Title:	Side Roll Protection (SRP) Resistor Leg Locations			
Number:	SB_702	Release Date:	07/23/2024	
Revision Number:	Not Applicable	Revision Date:	Not Applicable	
Chassis Type:	Custom Chassis			
Component Description:	Unused legs of SRP harness w/ resistors			
Tools:	Multimeter

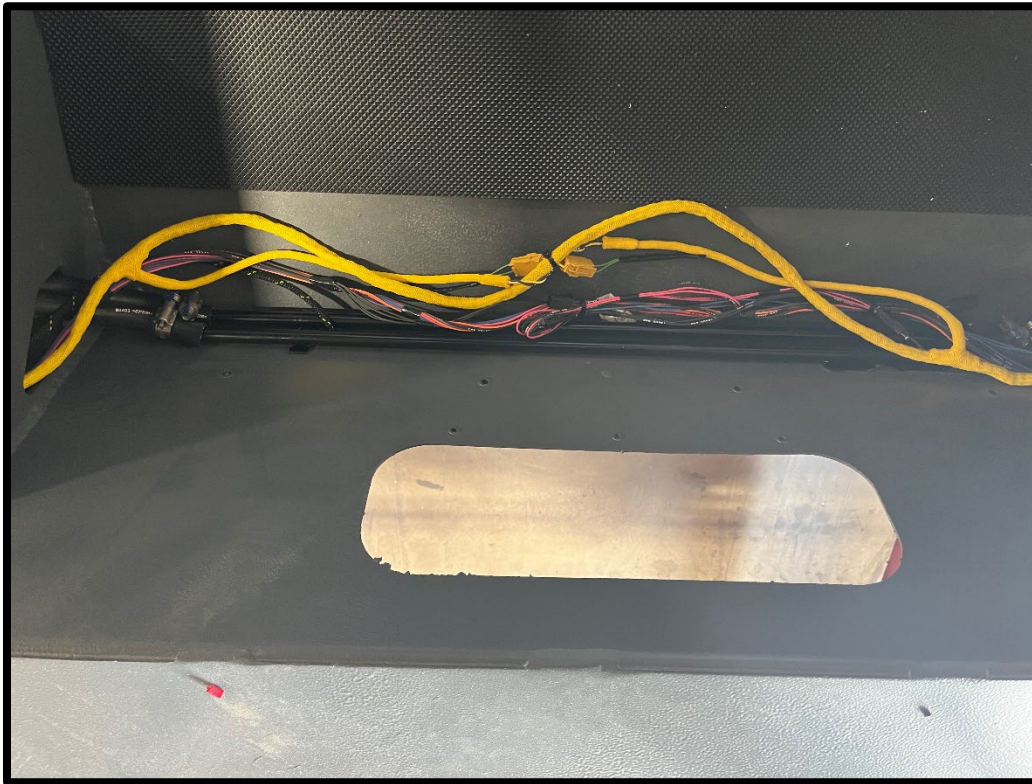
Remove necessary cover panels as required to gain access to unused SRP legs containing resistors.

Crew Cab Upper Left Corner

Crew Cab Upper Right Corner

Cover between Rear Facing Heaters
